DART AEROSPACE LTD	Work Order: 76044
Description: Crosstube Assembly (205/212 Low Aft)	Part Number: D212-664-247
Inspection Dwg: D212-664-247 Rev: B	Page 1 of 1

DRAWING NO. D212-664-247	TITLE CROSSTUBE ASS'Y (205 LOW AFT)	REV. B	DART AEROSPACE LTD ENGINEERING ORDER		D.E.O. NO. D212-664-247-B-1	SHEET NO. SHEET 1 OF 1	SCALE NTS
DRAWN 92	CHECKED ASS	MFG. APPR. [Signature]	APPROVED [Signature]		DE APPR. [Signature]		
DATE 11.07.15	DATE 11.07.20	DATE 11.07.21	DATE 11/07/21		DATE 11.07.21

PURPOSE:

REPLACE MAGNOBOND WITH PROSEAL.

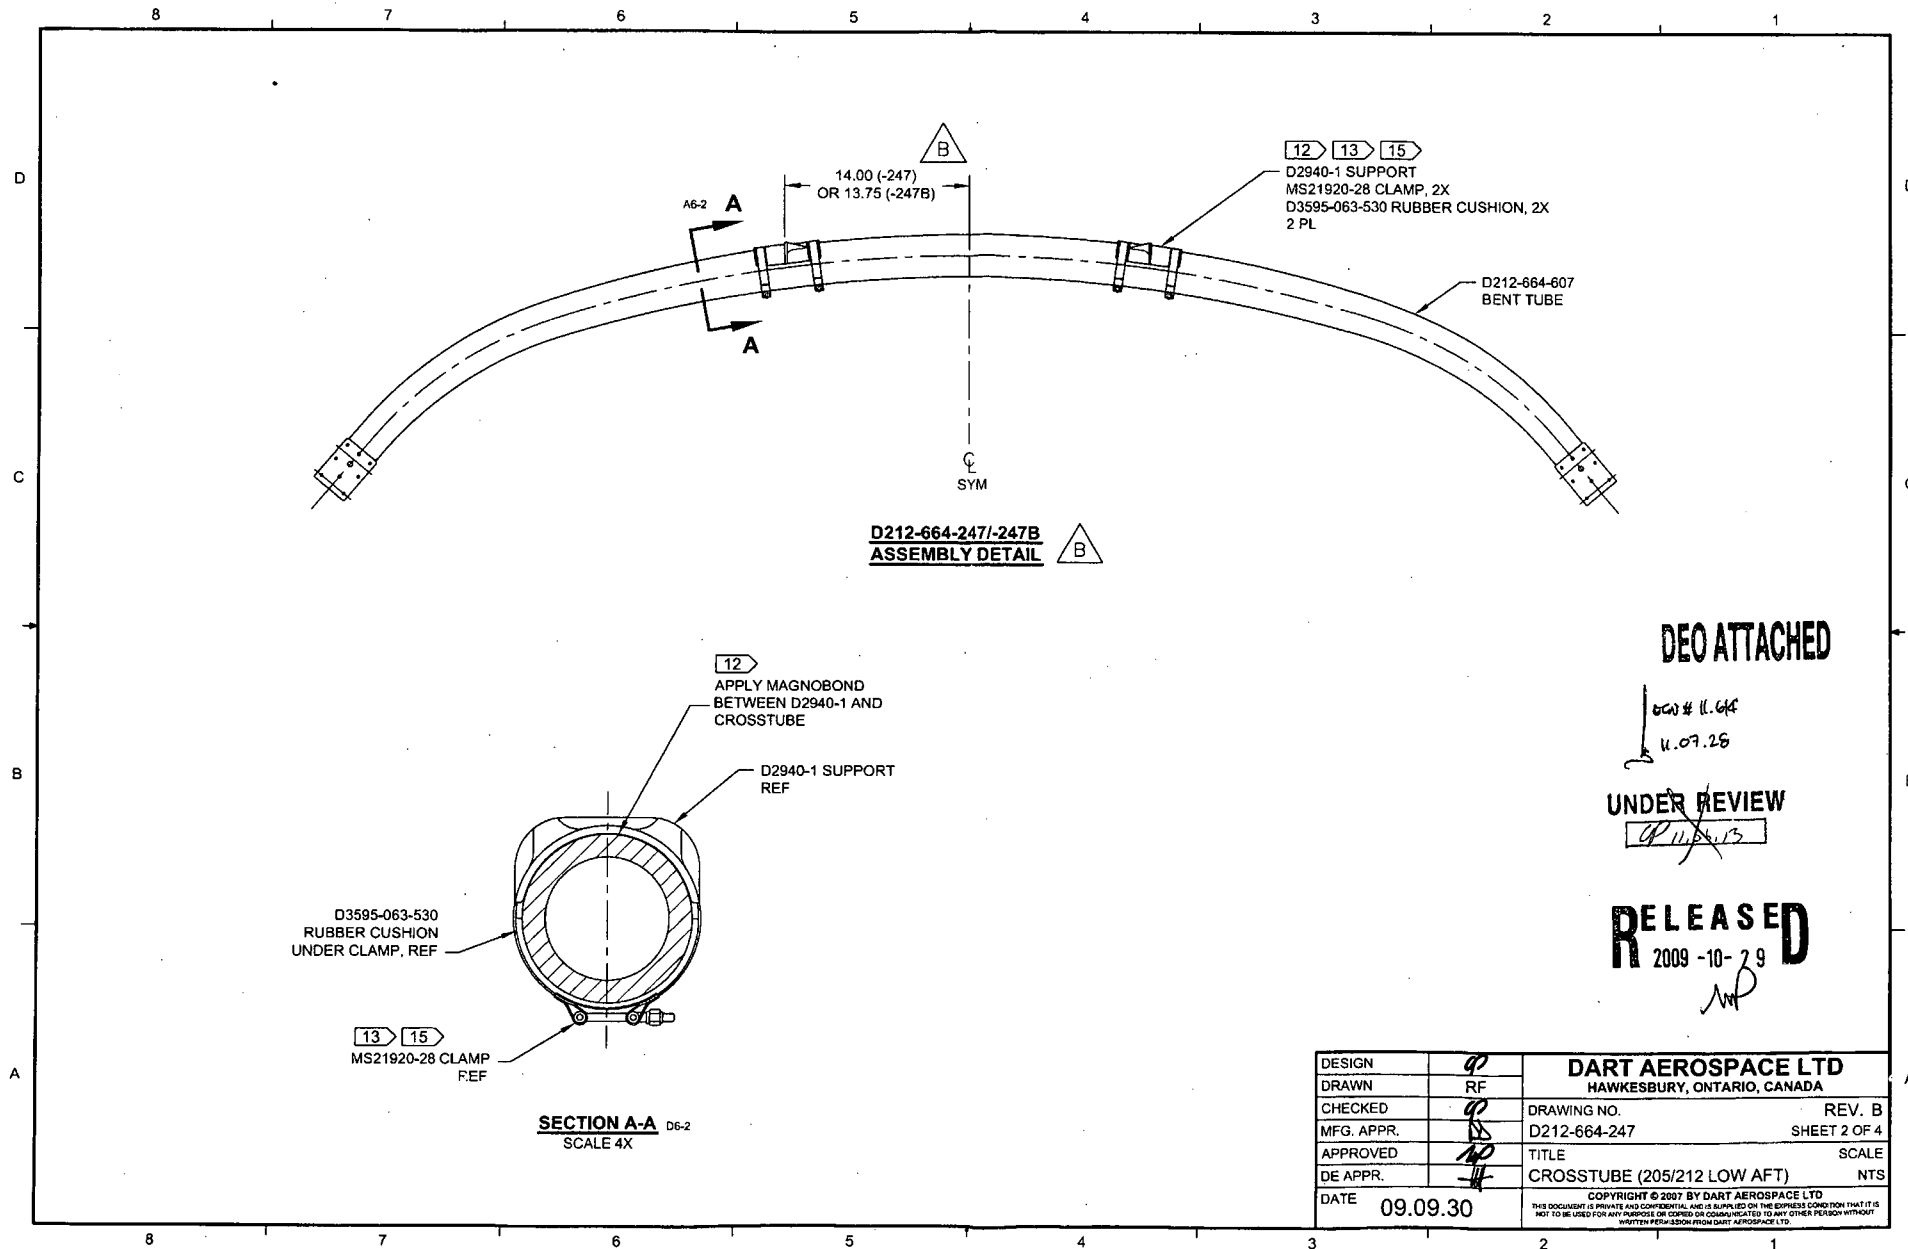
NOTE 12 & 15, SHEET 1 IS AMENDED AS FOLLOWS:

- 12) INSTALL D2940-1 SUPPORT USING 0.03" TO 0.06" THICK LAYER OF MAGNOBOND 6398 TO THE SURFACE OF D2940-1 THAT WILL BE IN CONTACT WITH THE CROSSTUBE PER QSI 015. LET CURE FOR 12 HOURS AFTER INSTALLATION AND PRIOR TO PACKAGING.
- 15) TORQUE CLAMPS 80 TO 100 IN-LB. ENSURE AT LEAST 1.5 THREADS SHOWING IN SAFETY AND THAT NUT HAS NOT BOTTOMED-OUT AFTER TORQUING.

- 12) TO INSTALL D2940-1 SUPPORT: ABRASE MATING SURFACE OF SUPPORT AND CROSSTUBE WITH 180-GRIT SANDPAPER AND REMOVE RESIDUE WITH MEK (OR EQUIVALENT). APPLY A 0.04" TO 0.07" THICK LAYER OF PROSEAL 890 CLASS B-2 (OR AMS-S-8802 CLASS B-2) SEALANT TO MATING SURFACE OF SUPPORT.
- 15) TORQUE CLAMPS 80 TO 100 IN-LB. ENSURE AT LEAST 1.5 THREADS SHOWING IN SAFETY AND THAT NUT HAS NOT BOTTOMED-OUT AFTER TORQUING. **PRIOR TO PACKAGING, RE-CHECK TORQUE ON CLAMPS AFTER PROSEAL 890 SEALANT HAS CURED FOR 72 HOURS.**
